Central Planning Authority

Agenda for a meeting of the Central Planning Authority to be held on **January 4, 2023 at 10:00am in Conference Room 1038, 1st Floor, Government Administration Building, and Elgin Avenue.**

CPA/01/23

Figure 1: A plan extract showing the limited setback of the existing seawall and the pool deck from the MHW of the cove (Source: John Doak Architecture 2022)

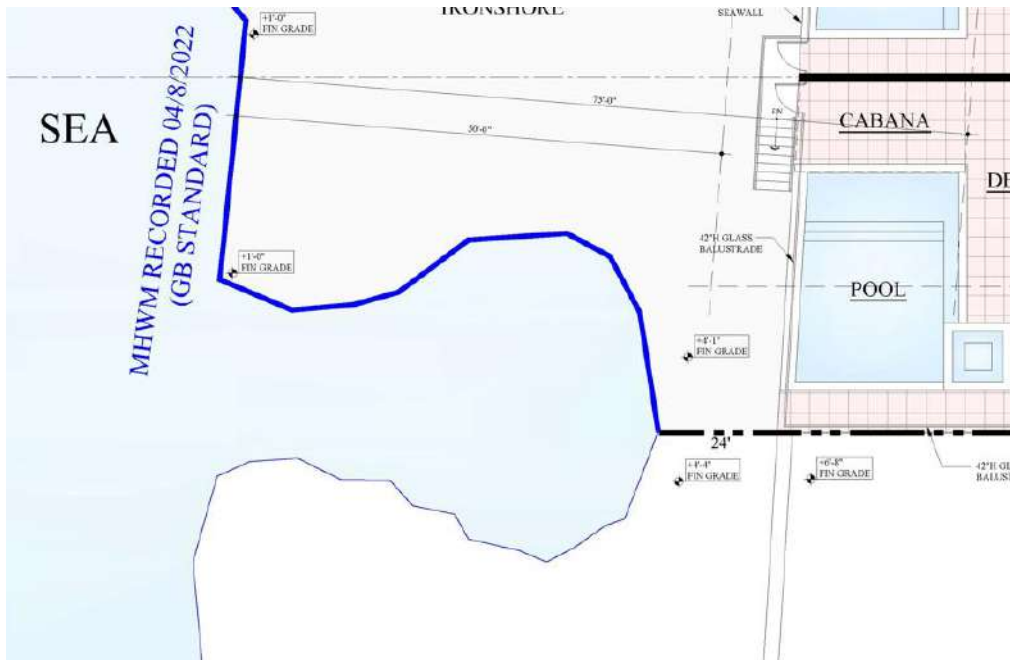
The DoE is also concerned about the limited setback of the edge of the seawall and pool deck from the MHW as it relates to the natural cove inlet on the coastline of the parcel. Although the plans show measured setbacks from part of the coast, they do not account for the setbacks relative to the MHW of the cove. As can be seen in Figure 1 above, the setbacks of the existing seawall and proposed pool deck are limited (approximately 12 ft). There are several examples of similar developments in this area which have experienced storm impacts or undermining of structures to such an extent that coastal engineering is now required. When a development is set too close to the Mean High Water Mark, there are limited appropriate solutions for addressing any structural issues that occur. Wave impacts to these proposed structures also pose a risk of indirect impacts to the Marine Reserve. In addition the threat of wave inundation could cause the flooding of the area landward of the seawall, this threat could be reduced by the use of features such as permeable paving that would better allow the drainage of water on the site.

The DoE recommends that the proposed setback for the swimming pool deck are increased as much as possible to reduce the impact to the development from wave inundation during storm events.

- *The proposed impermeable pool deck and landscaped areas shall be construction of semi-permeable materials in order to reduce the impact of water run-off from the property due to wave inundation or rainfall.*

Figure 1: DOE’s 2013 habitat map extract showing the application site outlined in red.

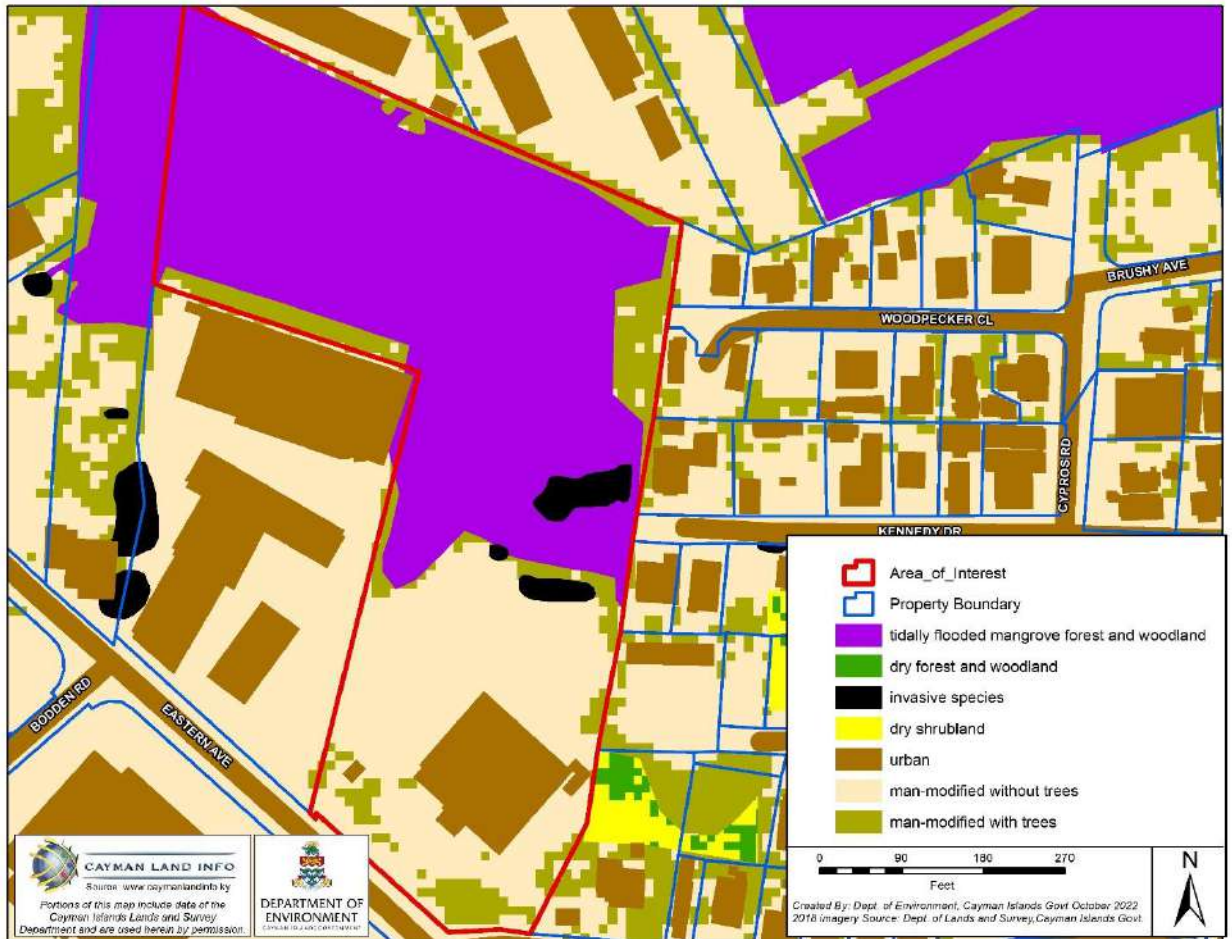
The northern part of the subject parcel consists of primary habitat classified as tidally flooded mangrove forest and woodland, as shown in Figures 1 and 2.

Mangroves are protected under Schedule 1, Part 2 of the National Conservation Act (2013). **It is an offence to remove mangroves unless permission is explicitly sought to remove them either through planning permission or a National Conservation Council Section 20 permit.**

- 1. All mangrove vegetation shall be retained in accordance with the National Conservation Council's Species Conservation Plan for Mangroves (2020).*
- 2. There shall be no land clearing, excavation, filling or development of the resultant subdivided parcels without planning permission for such works being granted.*

Figure 3: Cayman Land Info 2018 aerial extract showing the excavated facility at Spanish Cove.

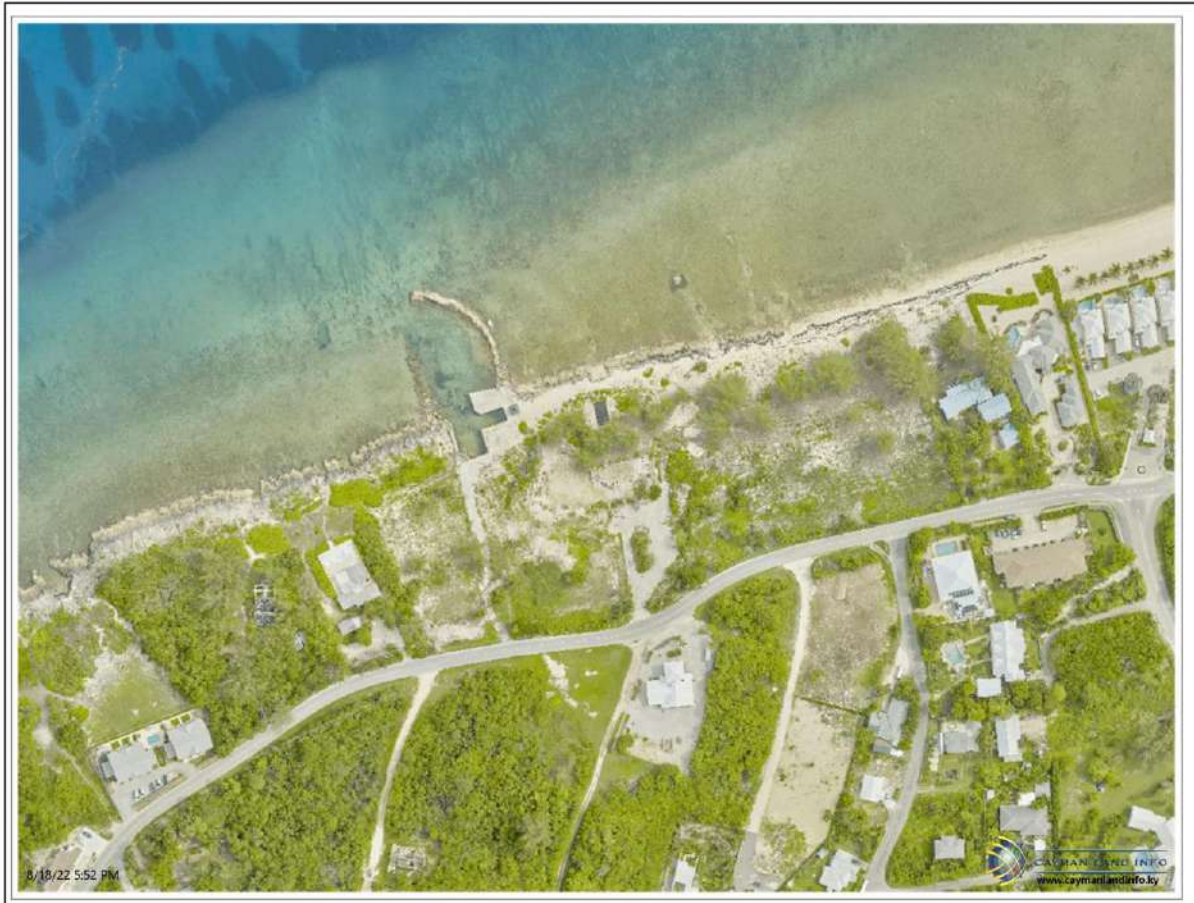
Spanish Cove, located to the west of the site along the same coastline, operated as primarily a dive resort. In order to facilitate watersports at that development, extensive modifications of the seabed were undertaken in the 1980s/1990s as shown in Figure 3 below. However, there are healthy seagrass beds offshore and the DoE would not support the dredging and construction of a similar facility at this location within the MPA.
